CITY OF ROSEBURG PLANNING COMMISSION

**CITY OF ROSEBURG
PLANNING COMMISSION
STAFF REPORT**

To: Planning Commission
From: Mark Moffett, Associate Planner
Subject: Merle Avenue Subdivision & Variance Request

In the matter of an application by i.e.) Subdivision
 Engineering, Inc. for a 10-lot Subdivision) File No. SUB-22-001
 with concurrent Variance to reduce) and concurrent
 right-of-way width from 60 to 40 feet) Variance
 on property located at 2240 NW Merle Avenue) File No. V-23-002

EXHIBIT # B
 SUB 22-001 + U-23-002

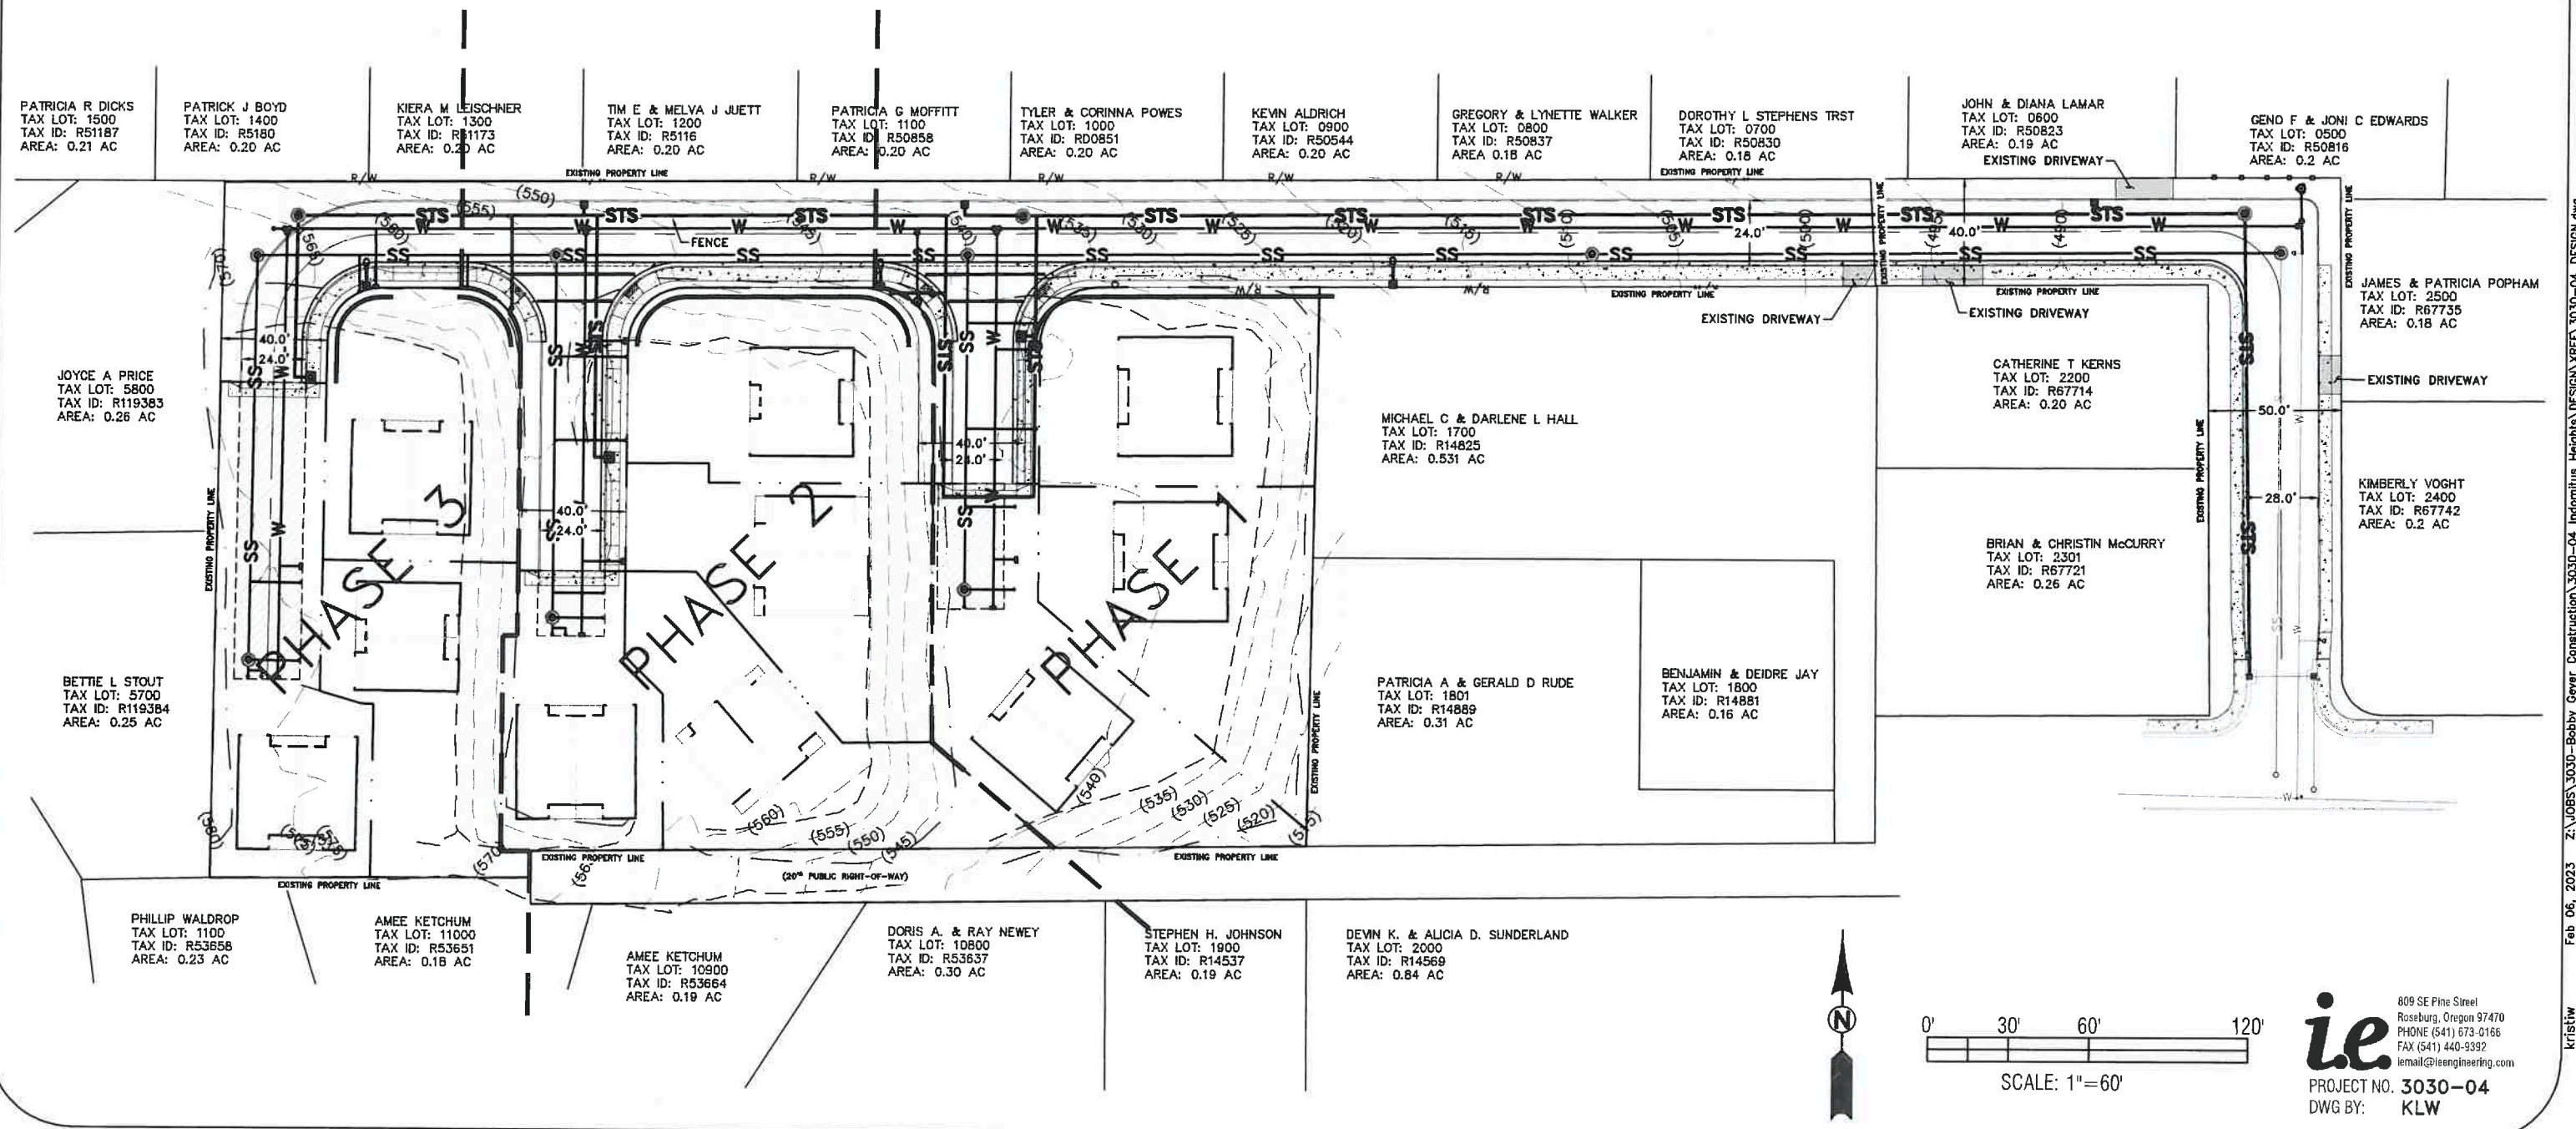
41. Preliminary subdivision plans do not indicate storm detention. Final plans will need to address detention.

In the original proposal only Lot 9 had an easement access, but the revised layout plan of February 8, 2023 removed the frontage access for Lot 2. *Until such time as lot 2 is provided again with regular street frontage at least 35' long, the access standards are not met. In addition, the three access and utility easements for lots 2, 7 & 9 need to be expanded to make direct contact with each lot.*

REVISED PLAN, RECEIVED 2/8/23

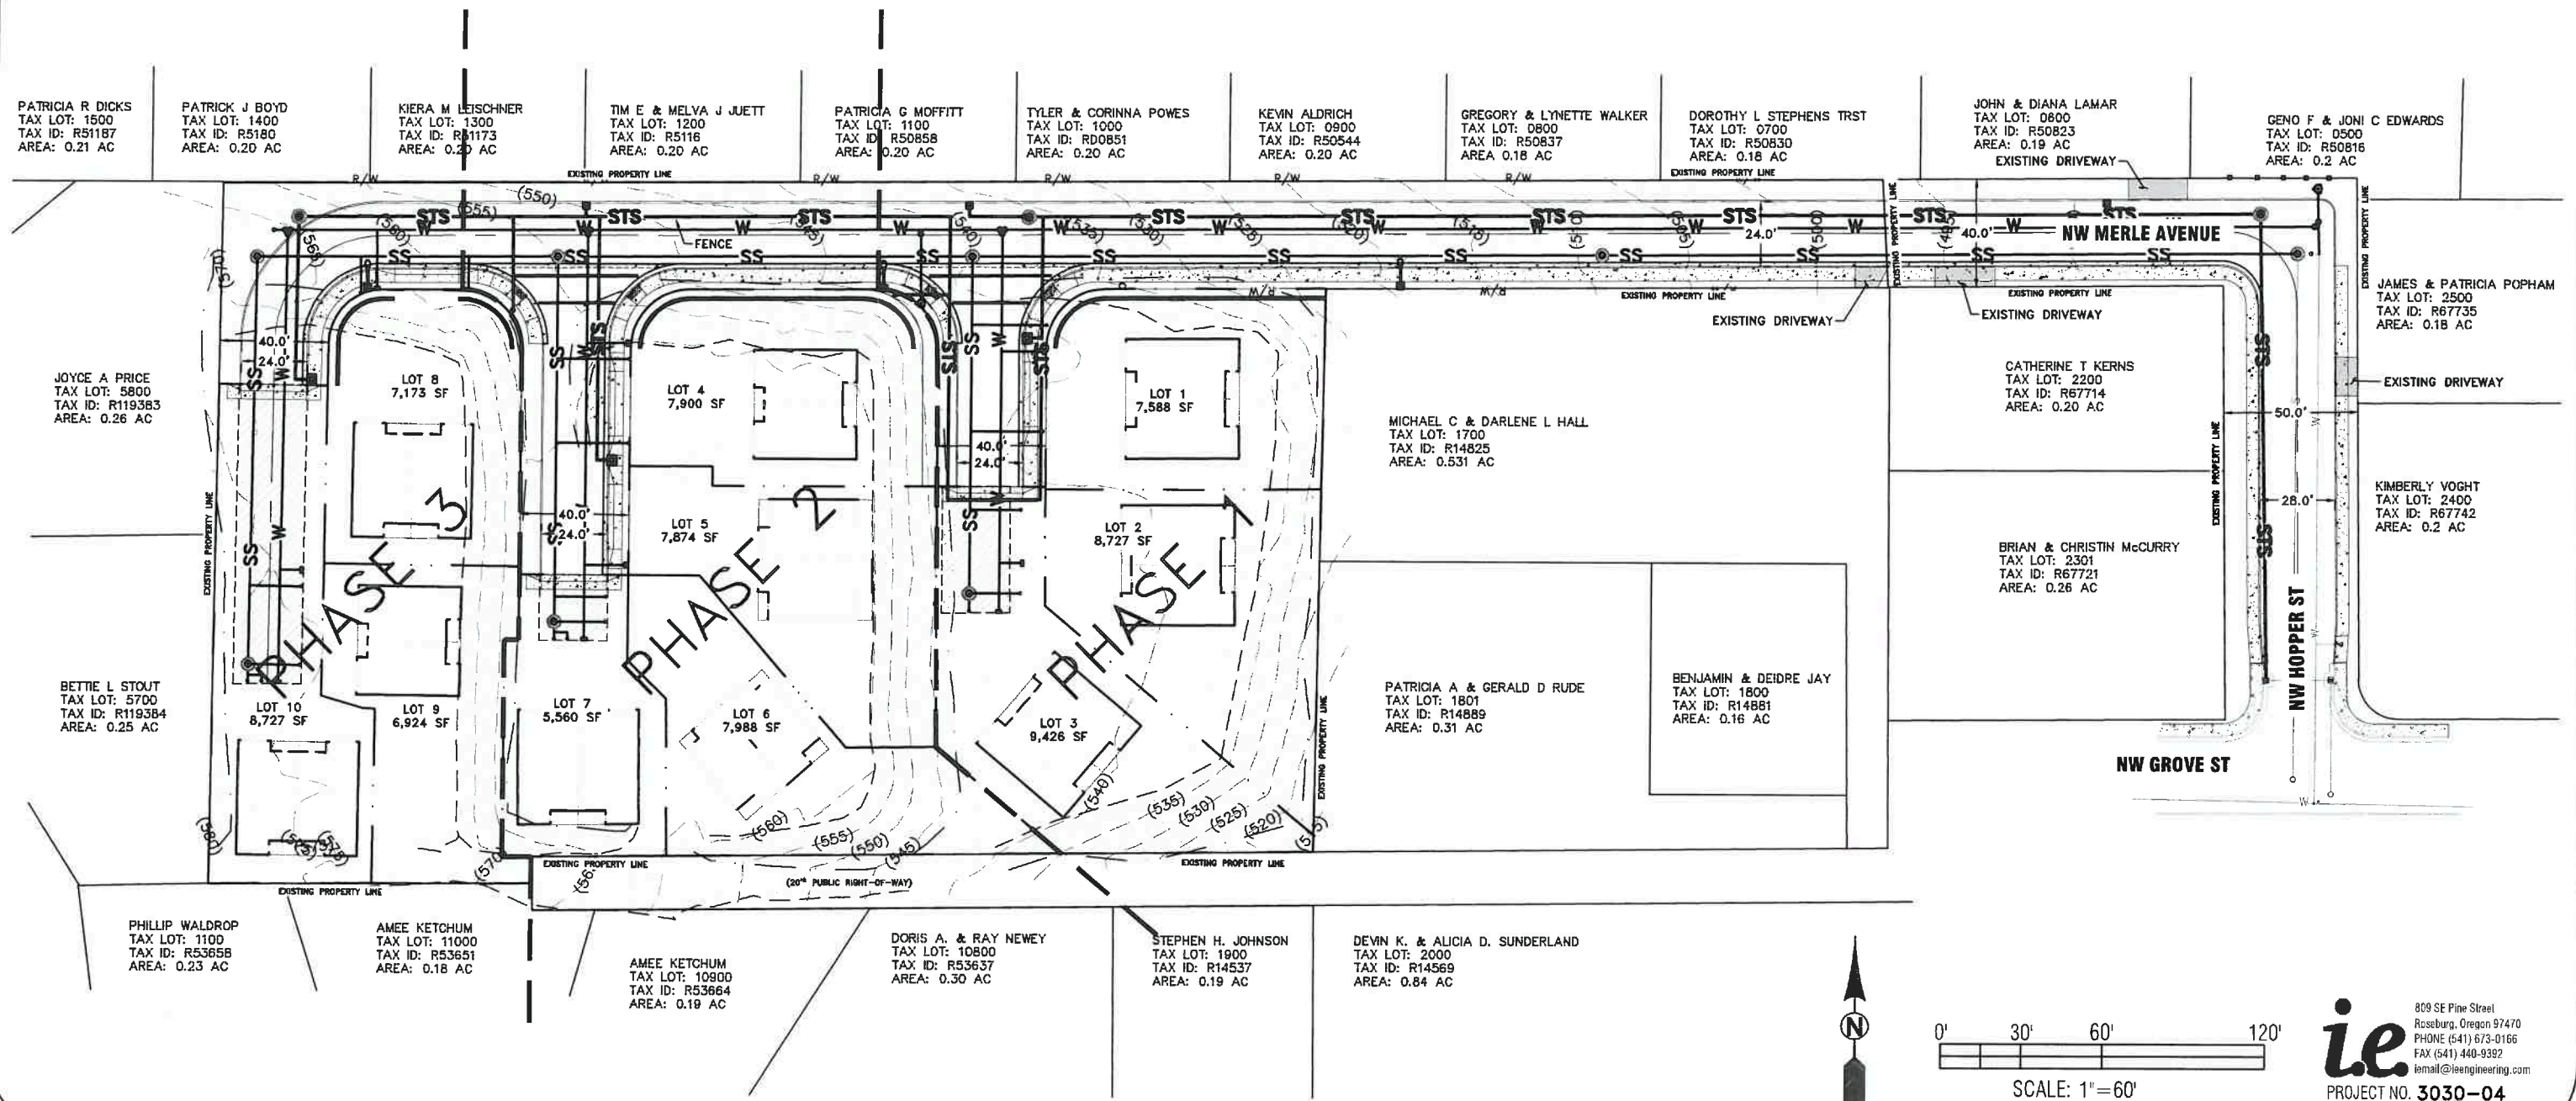
Encroachment of the new roadway onto property at 1780 NW Merle was corrected by the applicant through the submittal of a revised plan on February 8, 2023. Utility and driveway connections will be addressed during development of drawings and construction plans for the grading permit. Satisfactory construction of the new roadway in NW Merle and NW Hopper will be completed before individual lots can be developed. This application has no bearing on the behavior of individuals, and cannot resolve potential private civil or criminal claims against other property owners. Geotechnical concerns must be addressed in the application, including slopes, drainage, erosion control, the preservation of existing vegetation in hillside areas, and establishing plants or other measures to ensure the stability or potentially hazardous slopes.
